ADDENDUM #1

City of Berea Restroom

BG 24-016

DATE: September 23rd, 2025

1 MECHANICAL - HVAC PLAN
1/4" = 1'-0"

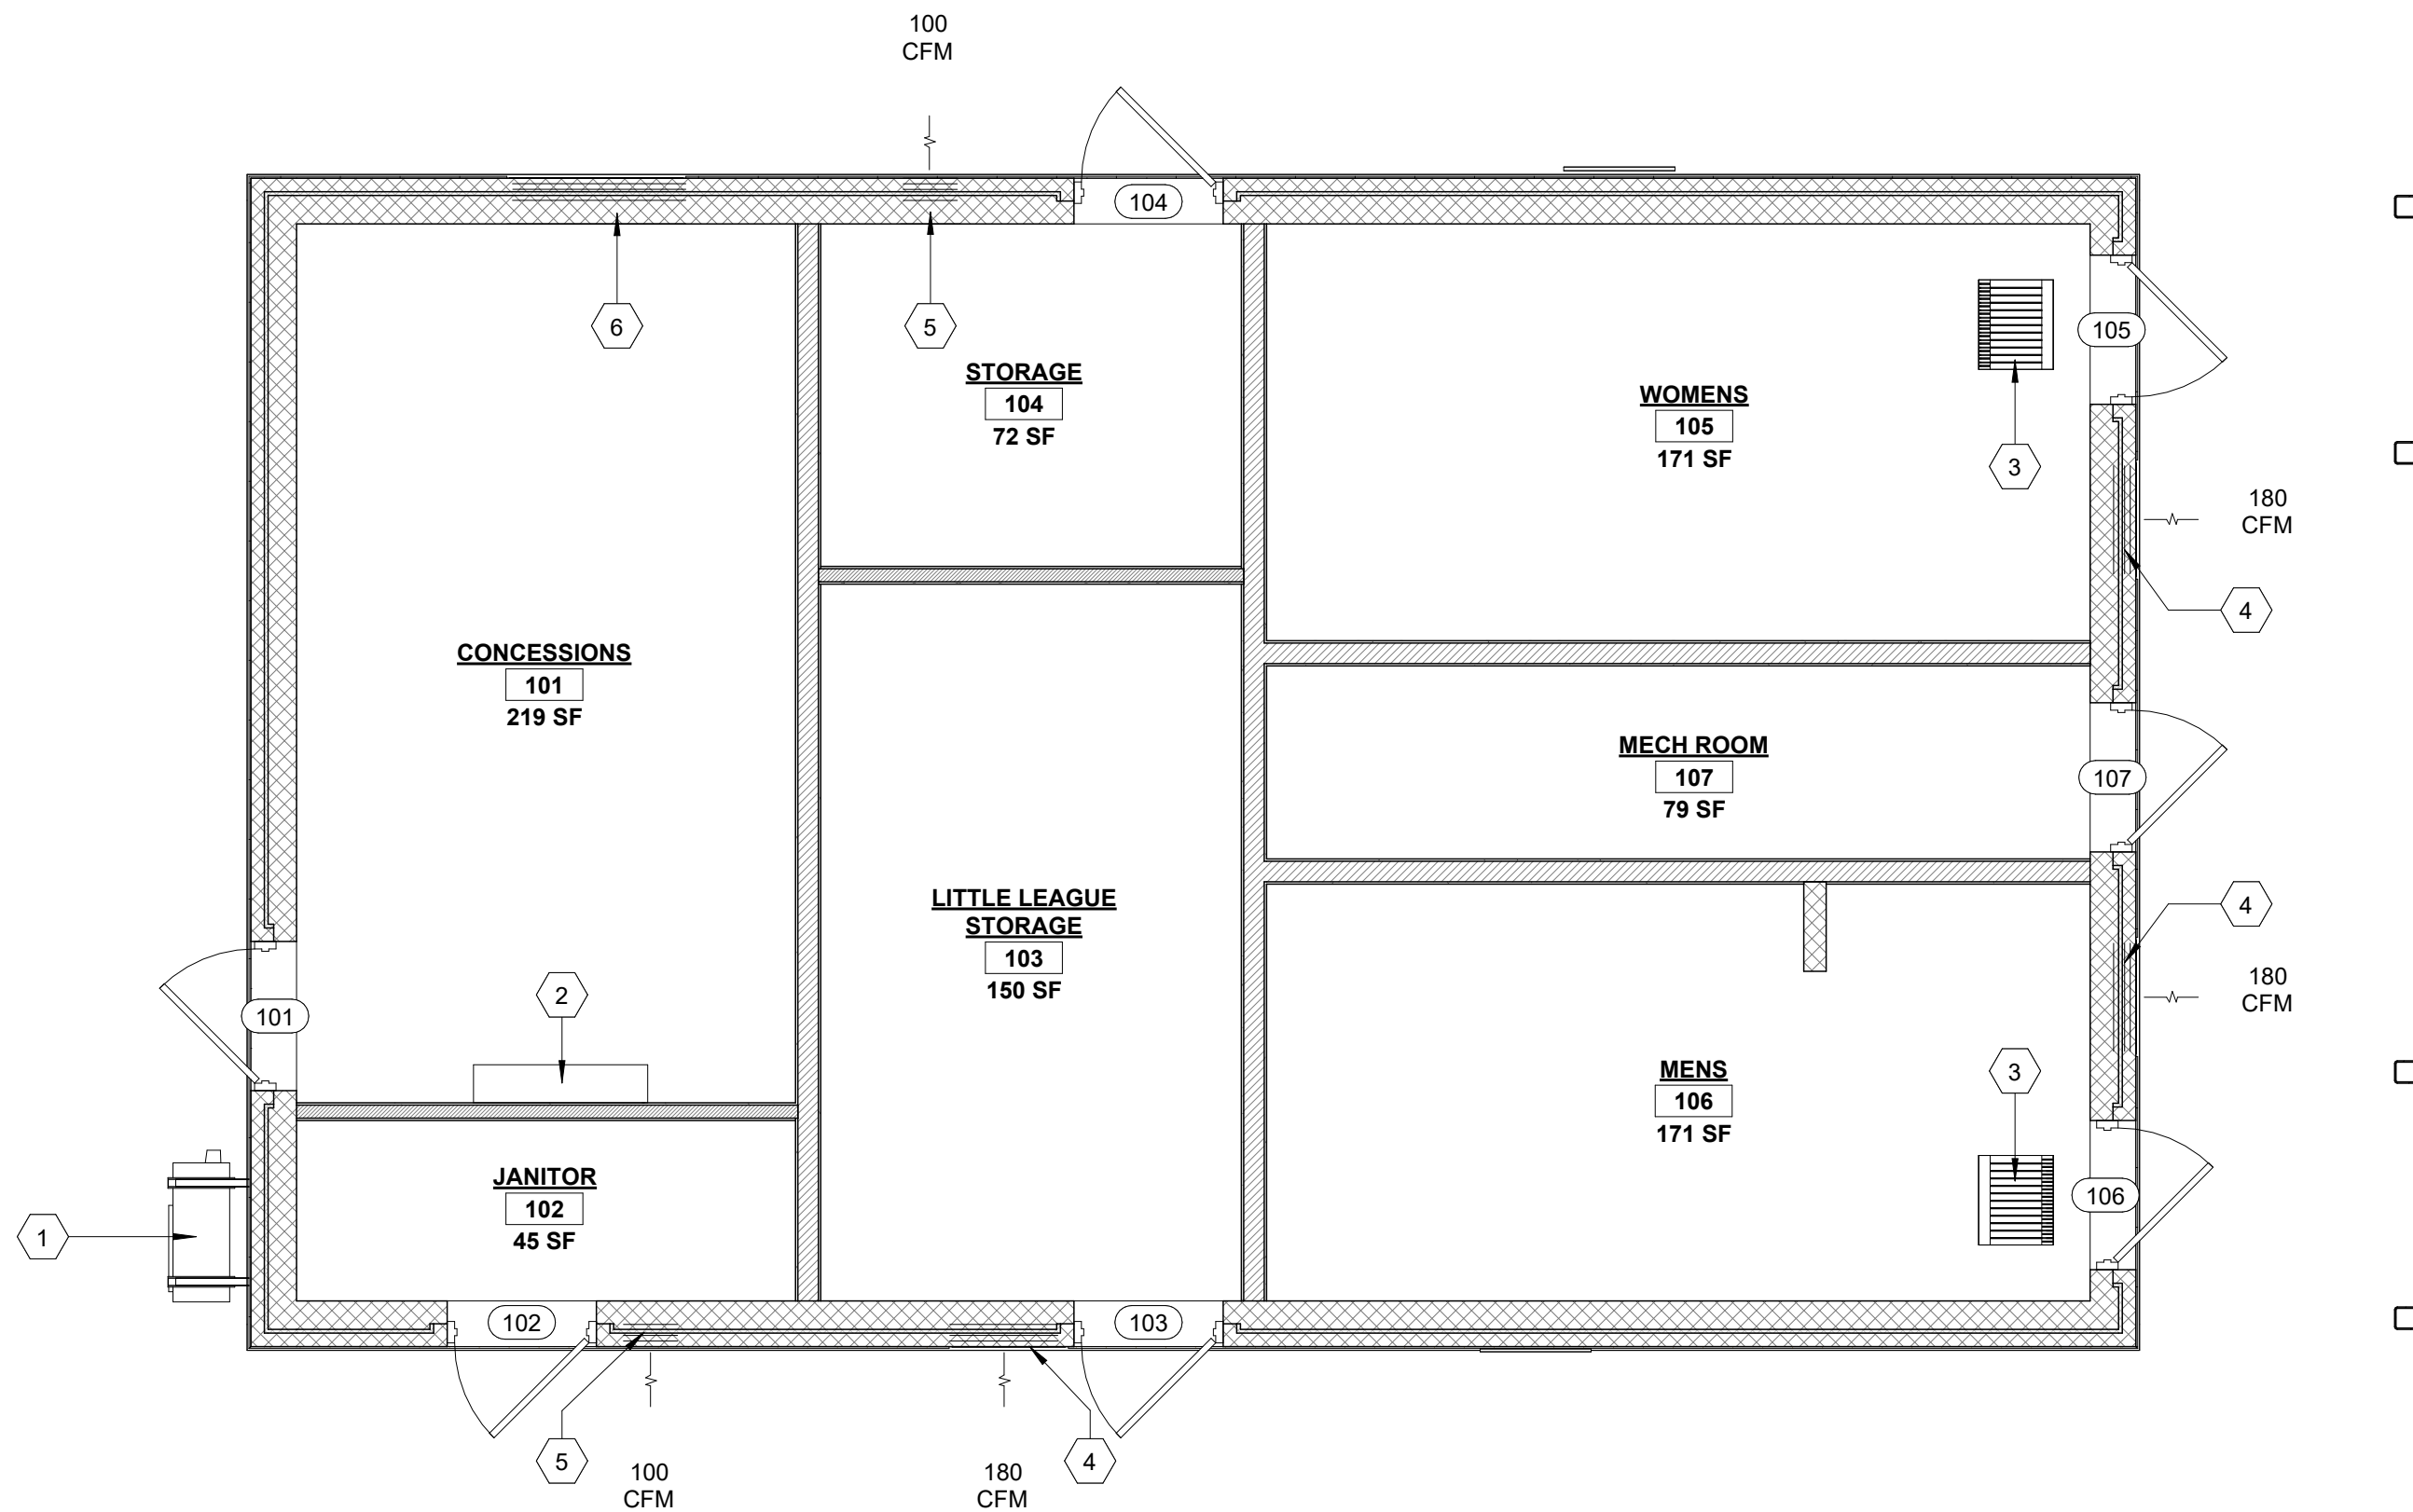
- a. Sheet note 3 will now read: DAYTON 2YU35 CEILING SURFACE MOUNTED HEATER. FAN FORCED. VARIABLE SPEED CONTROL SWITCH WITH COVERED KEY ACCESS BOX.
- 4. Refer to attached sheet M100; HVAC PLAN NOTES

- a. Sheet note 3 will now read: 16" X 32" LOUVER W/ INSECT SCREEN & 180 CFM EXHAUST FAN, INTERNAL 2YU46 THERMOSTAT ACCESSORY.
- 5. Refer to attached sheet M100; HVAC PLAN NOTES

ADDENDUM 1, ITEM 3

ADDENDUM 1, ITEM 4

ADDENDUM 1, ITEM 5

NOTE NUMBER	DESCRIPTION
1	LENNOX MPB009S4S-1P .75 TON MINI-SPLIT HEAT PUMP CONDENSER
2	LENNOX MWMB009S4-2L .75 TON MINI-SPLIT WALL MOUNT HEAT PUMP
3	DAYTON 2YU35 CEILING SURFACE MOUNTED HEATER. FAN FORCED VARIABLE SPEED CONTROL SWITCH WITH COVERED KEY ACCESS BOX.
4	16" X 32" LOUVER W/ INSECT SCREEN & 180 CFM EXHAUST FAN, INTERNAL 2YU46 THERMOSTAT ACCESSORY
5	8" X 16" LOUVER W/ INSECT SCREEN & 100 CFM EXHAUST FAN, INTERNAL 2YU46 THERMOSTAT ACCESSORY
6	16" X 48" OPERABLE LOUVER W/ INSECT SCREEN
